Nipa Fashion Wear Ind. Ltd.--Extended Building

Selina Tower - 6, Holan Road, Islam Bag, Dhaka
(23.85637, 90.43121)

8th June 2021

Observations

In design report the Response modification co-efficient factor $R=8$

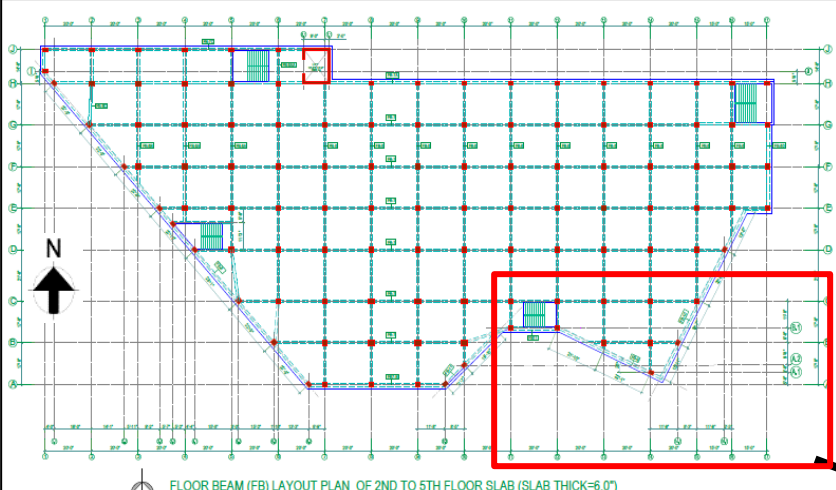
The value of Response modification co-efficient factor “R” found mismatch between the FEA model and design report. In design report The value of “R” has been considered 8 where as the value of R has been assigned 5 in FEA model. Moreover the value of $R=8$ has been written in report but mentioned as OMFR instead of IMRF.

In FEA model the Response modification co-efficient factor $R=5$

As per BNBC every building or structure designed shall have its design documents prepared in accordance with the provision of Section 1.9.1. The design document shall include a design report, and a set of structural drawings, which shall be prepared in compliance with section 1.9.1.1 and section 1.9.1.2 as per BNBC. Factory engineer is required to update the design documents and FEA model in compliance with section 1.9.1 (part-6, BNBC).

Beam Layout plan

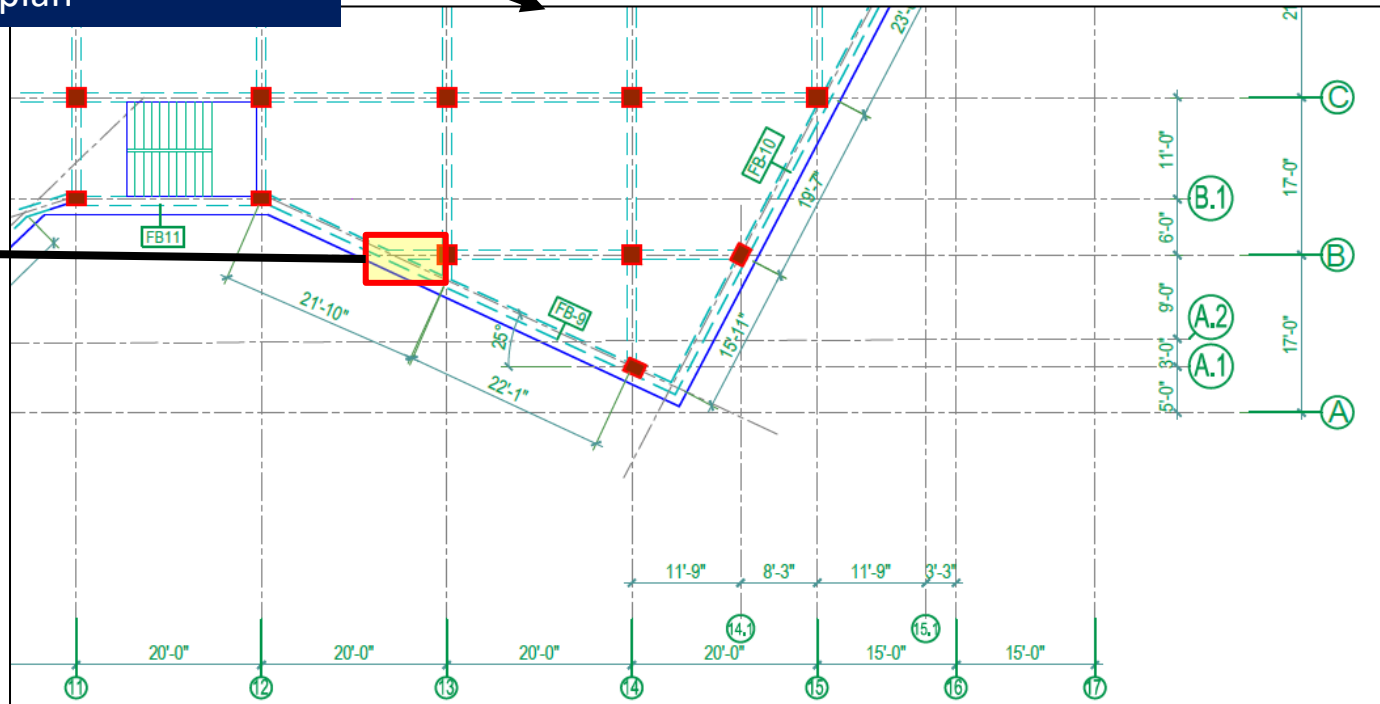
Beam layout plan does not match with the as-built drawing. A beam marked in the layout has been shown in drawing but during inspection, the beam was not found at site condition. Factory engineer is required to survey the structures and prepare accurate as-built drawings.

Toilet Build-up Found

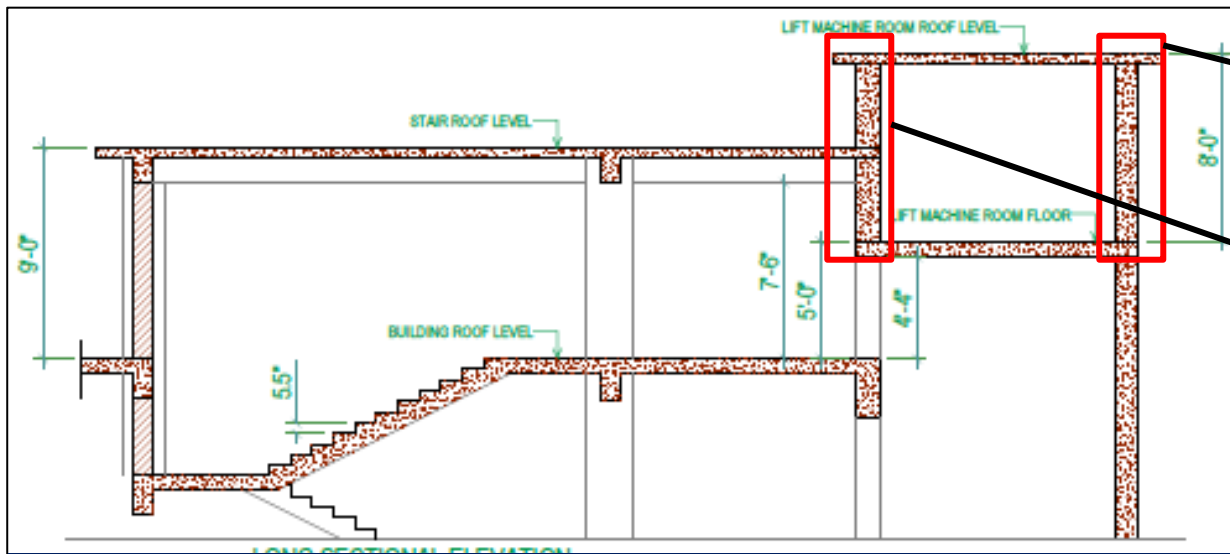
Build up was found approximately 317 mm at all the toilet zone area. But the build up information has not been provided in architectural drawing. Factory engineer is required to survey the whole structure and update the accurate as-built architectural drawing.
